City of Merced
MEMORANDUM

DATE: February 4, 2016
TO: City Council and Planning Commission
FROM: Kim Espinosa, Planning Manager
SUBJECT: Final Recommendations from Merced Zoning Ordinance Update Focus Group regarding Specific Items from the Planning Commission/City Council Study Session on December 7, 2015

Figure 20.22-9

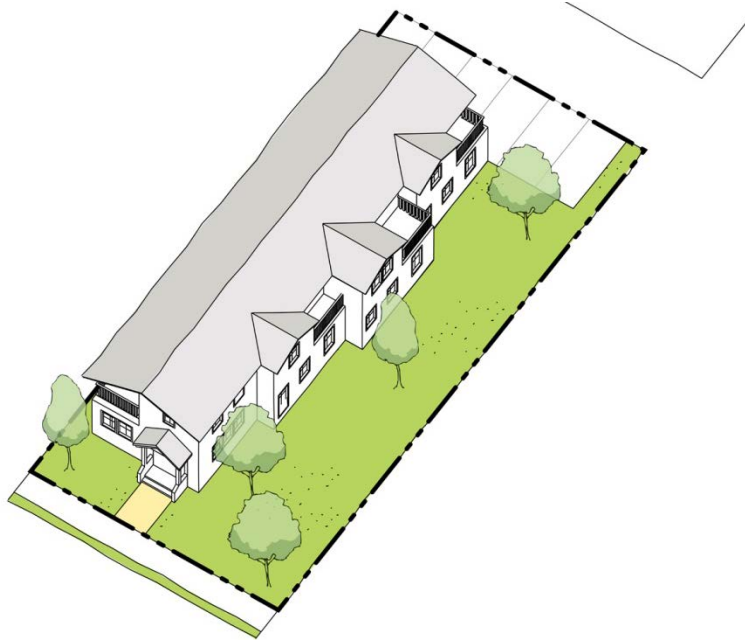
- 4) *Side Court Apartments:* The Focus Group recommended that the following additional subsections be added: “4a) The side courtyard shall be a shared space accessible to all building residents. 4b) Pathways shall be provided from each unit to the side courtyard and from the side courtyard to a public sidewalk adjacent to the site.”

Page 84 h Side Court Apartments. Add sections (3) Pedestrian Access; (4) Central Courtyard; and (5) Frontage found on page 86 describing standards for Courtyard Apartments to provide residents good access to outdoor common areas.

Proposed New Language to be Added which matches that from Section 20.22.040.D3i for Courtyard Apartments below:

- (3) **Pedestrian Access.** The primary entry to individual units or the interior lobby of a courtyard apartment building shall be through the central courtyard.
- (4) **Central Courtyard.**
 - a) The central courtyard shall be a shared space accessible to all building residents.
 - b) Pathways shall be provided from each unit to the central courtyard and from the central courtyard to a public sidewalk adjacent to the site.
 - c) The central courtyard shall be visible from the primary street frontage.
 - d) The amount of impervious surface in central courtyard shall not exceed 50 percent of the total courtyard area.
 - e) The central courtyard shall be at least 30 feet in width.
- (5) **Frontage.** The active side yard shall front the street on a corner lot.

FIGURE 20.38-2 PARKING LOT LANDSCAPING STANDARDS

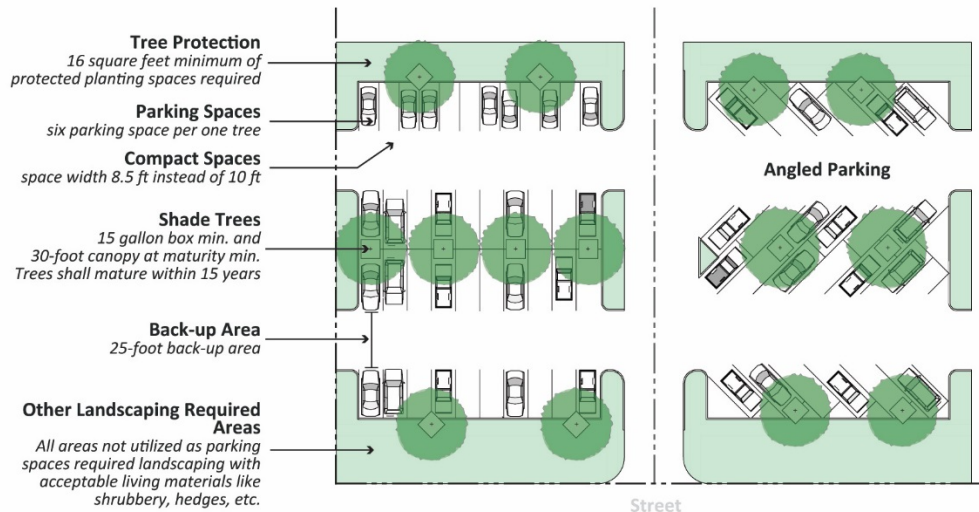
- 6) *Standards for Solar Carports:* The Focus Group recommended that such standards be developed by staff and presented to City Council in the future due to the evolving nature of this technology but should not hinder the adoption of the ordinance at this time.

Page 132 Parking lot do standards not provide uniform, predictable design guidelines for incorporating solar panel "carports" which conflict with landscape requirements. There are no clear standards in the solar panel section of the ordinance on page 160 either regarding parking lot landscaping. We need staff to develop alternate draft standards to consider.

- (5) The above standards may be modified with a Minor Use Permit if alternative shade structures are provided. **[Proposal is to add standards for shade structures and solar carports instead of leaving up to staff to address with Minor Use Permits]**
